**NOTE:**

For clutches with rigid releaser connections, both the release collar and the diaphragm spring have been optimized. This reduces the possibility of transport damage and handling error.

**The relevant component numbers are: 3483 ... .. as well as 3488 ... .. .**

*Fig. 2: Six guide tabs*

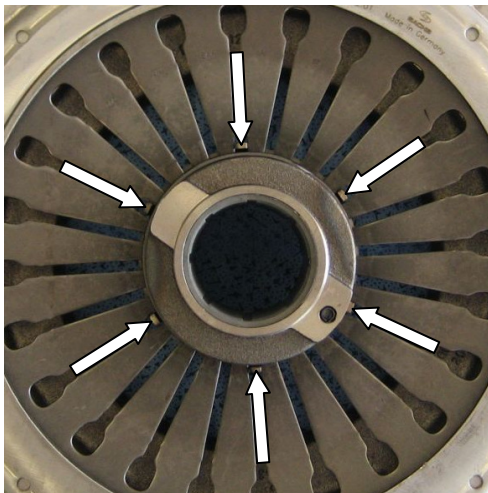
Figure 2 shows the six guide tabs on the rigid connection; the previous version had only three guide tabs.

**When repairing SACHS models, the old clutch cover can be used with the new releaser connection.**
